# DISTRIBUTION CODE MODIFICATION PROPOSAL FORM

<b>Modification Proposal submitted By:</b>  Tony Hearne	<b>DATE OF SUBMISSION OF PROPOSAL:</b> 29.10.2020	<b>Modification Proposal Number:</b> <i>(to be assigned by Review Panel Secretary)</i>  <b>#49</b>
<b>CONTACT DETAILS FOR MODIFICATION PROPOSAL ORIGINATOR: (IF NOT DISTRIBUTION CODE REVIEW PANEL</b>		
<b>NAME:</b> Tony Hearne		<b>TELEPHONE NUMBER:</b> <b>087 2238855</b>
<b>E-MAIL ADDRESS:</b>	tony.hearne@esb.ie	
<b>MODIFICATION PROPOSAL TITLE:</b>	Housekeeping corrections/clarifications to V7 relating to reactive power	
<b>DISTRIBUTION CODE SECTION(S) AFFECTED BY PROPOSAL</b>		
DCC11.5.1 DCC11.5.3.1 DCC11.5.3.2 DCC11.5.3.3 DCC11.6.2.3		
<b>MODIFICATION PROPOSAL DESCRIPTION</b> <i>(Clearly state the desired amendment and all text changes. Attach further information if necessary)</i>

Figure 6: Reactive power capability of PPM connected to distribution system

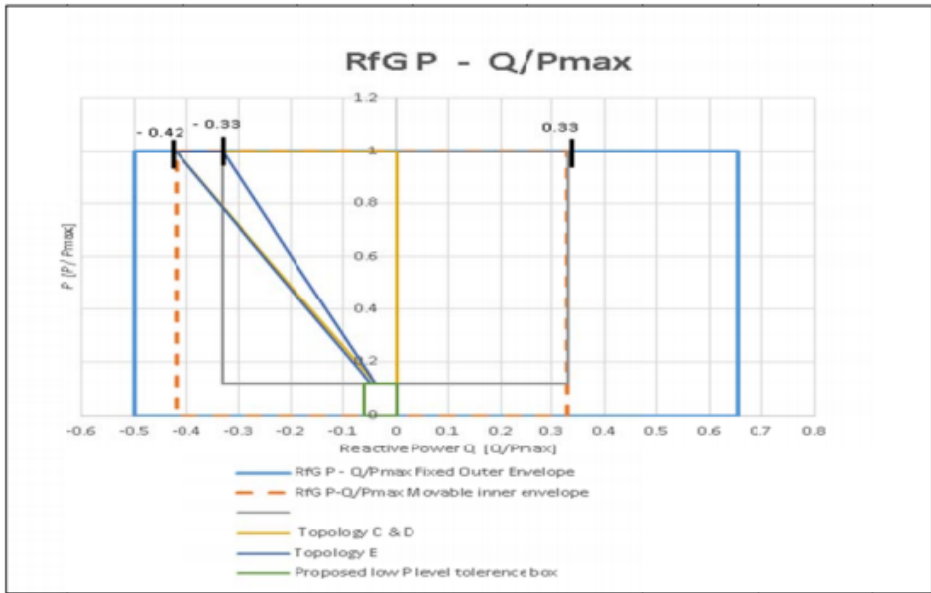
The reactive power requirements for wind generators in the existing Distribution Code are consistent with the P-Q inner and outer envelopes stipulated by RfG and **hence no change is required**. This is depicted diagrammatically in Figure 6 below. For consistency, these diagrams are shown in a tabular format in the following pages.
